**Historical Architectural Review Board
COA Preliminary Review Sheet**

HDC-2023-00082

Address: 515 N. Park Street

Proposal: Remove slate shingles; install asphalt shingles

**Front façade of 515 N. Park Street, 2019.
(Google StreetView)**

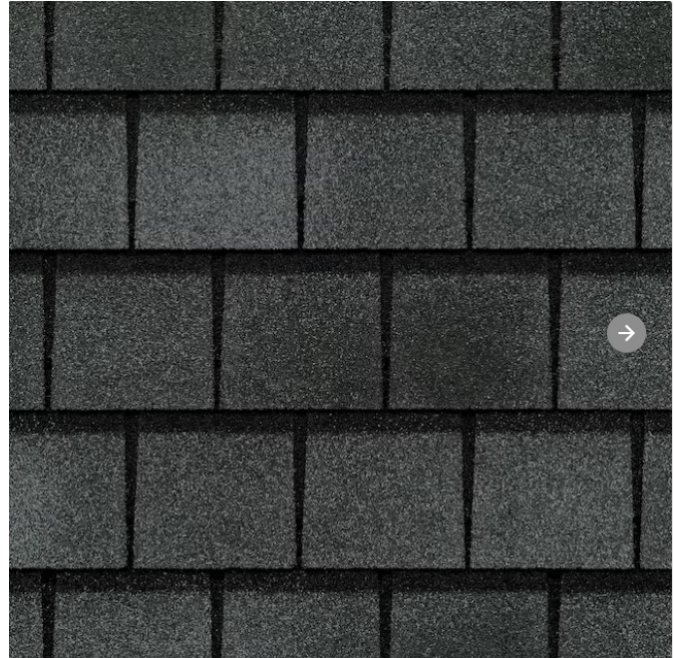
The applicant contends that the existing slate roof is failing and in poor condition. The current roof contains typical rectangular slate singles in a gray color. The application proposes to install GAF Slateline shingles, which are an appropriate alternate that generally match the existing rectangular slate in dimension, shape, profile, color, exposure, and overall appearance. Staff finds that the proposed shingle complies with the guidelines in Section 3.1 Roofs.

Discussion: The Discussion of the proposed work focused on the scope of work, the condition of the existing slate roof, and the color of the proposed GAF Slateline singles. The applicant asked to amend the application to include the cheek walls and roof of the dormer. Mr. Huber asked about the condition of the slate and the applicant said several roofers inspected the roof and said it was not repairable. She said the roofs adjacent to the attached home had been replaced. It was also pointed out that staff had determined the roof replacement with GAF Slateline shingles appropriate. The

Mr. AJ Jordan moved to approve the amended application presented on 1/8/2023 for the removal of slate shingles, including the cheek walls and roof of the dormer, and installation of GAF Slateline shingles at 515 N. Park Street pursuant to Chapter 3, Section 3.1 Roofs, with the following conditions:

- the replacement GF slate line shingles will match the existing slate in dimension, shape, profile, color exposure, and overall appearance.
